April 8, 1996

SERIAL: BSEP 96-0061  
10 CFR 50.90  
TSC 95TSB32

BRUNSWICK STEAM ELECTRIC PLANT, UNIT NO. 1  
DOCKET NO. 50-325/LICENSE NO. DPR-71  
REQUEST FOR LICENSE AMENDMENT  
FUEL CYCLE 11 RELOAD LICENSING

BRUNSWICK STEAM ELECTRIC PLANT, UNIT 1  
NRC DOCKET NO. 50-325  
OPERATING LICENSE NO. DPR-71  
REQUEST FOR LICENSE AMENDMENT  
FUEL CYCLE 11 RELOAD LICENSING

SODIUM PENTABORATE SOLUTION  
VOLUME CONCENTRATION RANGE COMPARISON

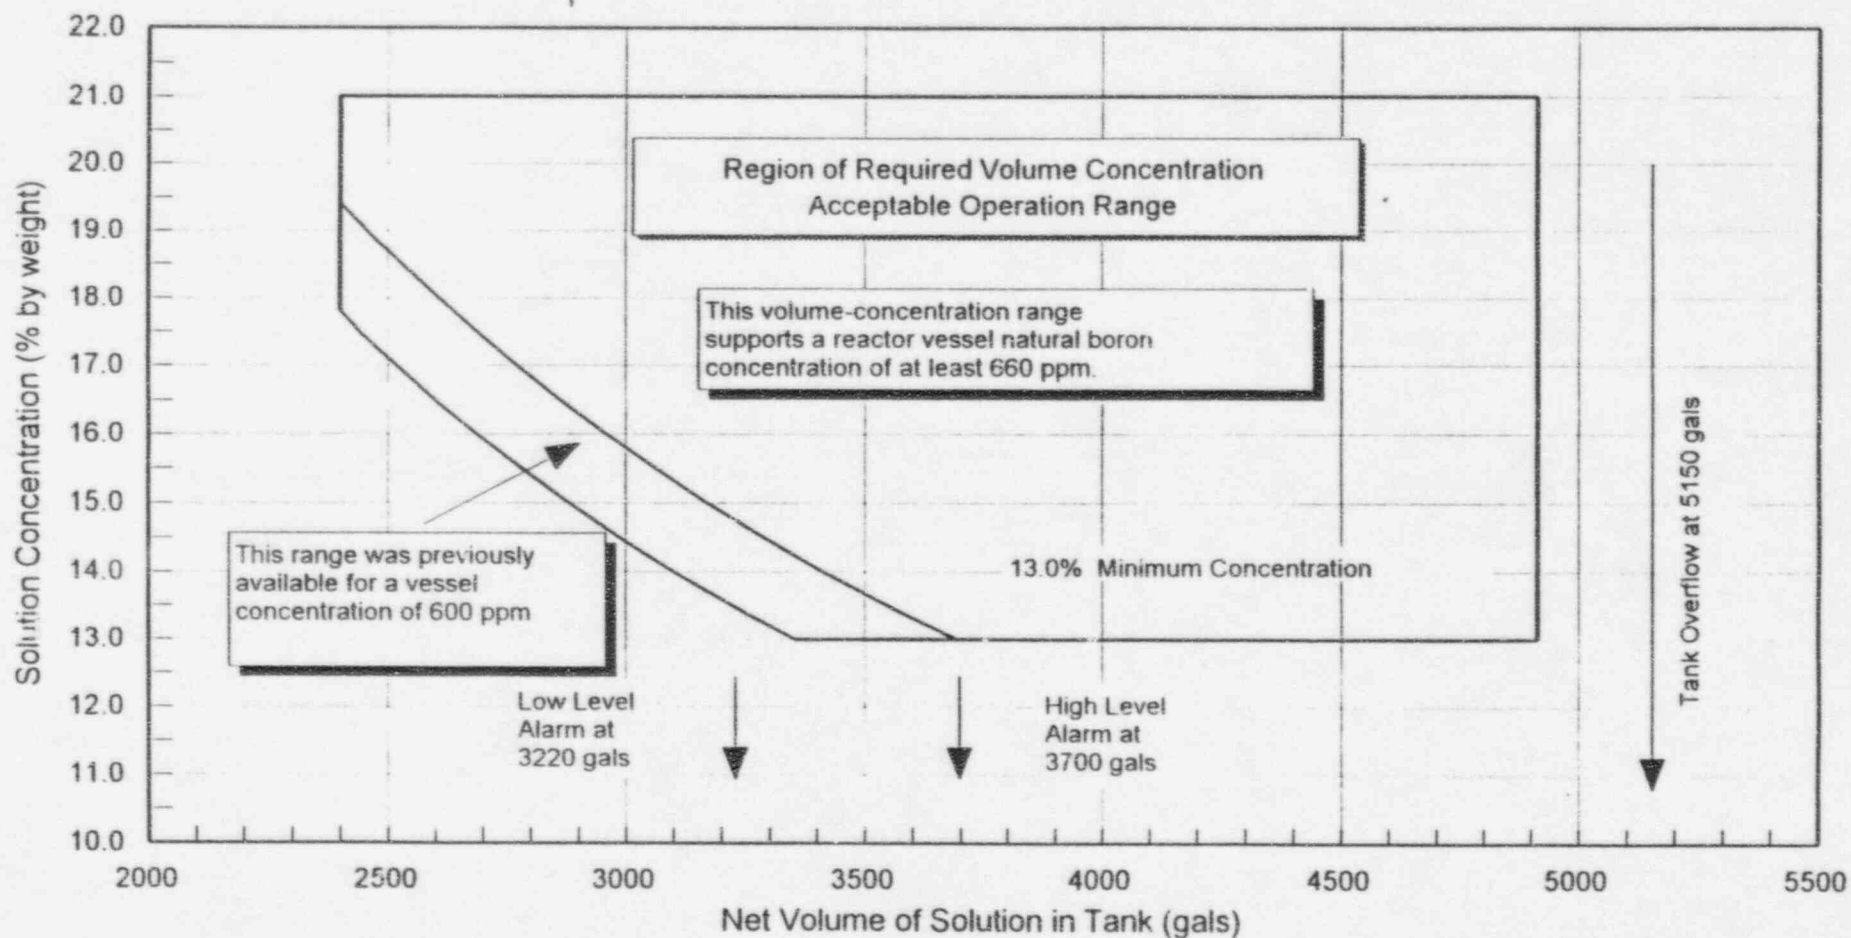
Revise the acceptable sodium pentaborate volume-concentration range for the standby liquid control system shown in Technical Specification Figure 3.1.5-1 to reflect changes to poison

material concentration needed to achieve reactor shutdown based on planned use of the new GE13 fuel type.

During normal operations, the standby liquid control system tank concentration is maintained in a range from approximately 16 percent to 17 percent to provide sufficient margin to avoid the occurrence of a dilution/precipitation event. If the minimum concentration at the tank low level alarm (3,220 gallons) is raised from 13.4 percent to 14.8 percent, the tank concentration for normal operation would need to be maintained above this range to provide margin between the working concentration and the Technical Specification limit.

The proposed SLCS tank volume-concentration range falls within the current acceptable range specified by Technical Specification Figure 3.1.5-1. The change in volume-concentration range, for one or two pump operation, would still result in SLCS injection times within the ranges stated in the Updated FSAR. Also, increasing the minimum sodium pentaborate volume-concentration does not require a change to the SLCS minimum pump flow rates (for one pump operation, as stated in Technical Specification 4.1.5.c.2).

The portion of the sodium pentaborate concentration range shown in Technical Specification Figure 3.1.5-1 applicable to the lower range of tank volumes is being revised to increase the required concentration of sodium pentaborate solution. This change is needed to account for the additional shutdown reactivity needed based on the planned use of GE13 fuel assemblies as reload fuel for the Unit 1 reactor core. Since the standby liquid control system is independent from the normal means of controlling reactor core reactivity and not used to control core reactivity during normal plant operations, the proposed revision to the sodium pentaborate concentration curve for the standby liquid control system does not alter any plant safety-related equipment, safety function, or plant operations that could change the probability of an accident.

As previously stated, the purpose of the standby liquid control is to inject a neutron absorbing solution into the reactor in the event that a sufficient number of control rods cannot be inserted to maintain subcriticality. Sufficient solution is to be injected such that the reactor will be brought from maximum rated power conditions to subcritical over the entire reactor temperature range from maximum operating to cold shutdown conditions. General Electric methodology establishes a fuel type dependent standby liquid control system shutdown margin to account for calculational uncertainties. General Electric calculations show that an in-vessel concentration of 660 ppm will provide a standby liquid control system minimum shutdown margin in excess of the 3.2%  $\Delta k$  value required for the GE13 fuel. To achieve an in-vessel concentration of 660 ppm, the acceptable range of standby

liquid control system tank concentrations is being revised for the lower range of tank volumes. Thus, the proposed revision of the standby liquid control system sodium pentaborate volume-concentration range ensures that there will not be a significant reduction in the amount of available shutdown margin and, therefore, not a significant reduction in the margin of safety.
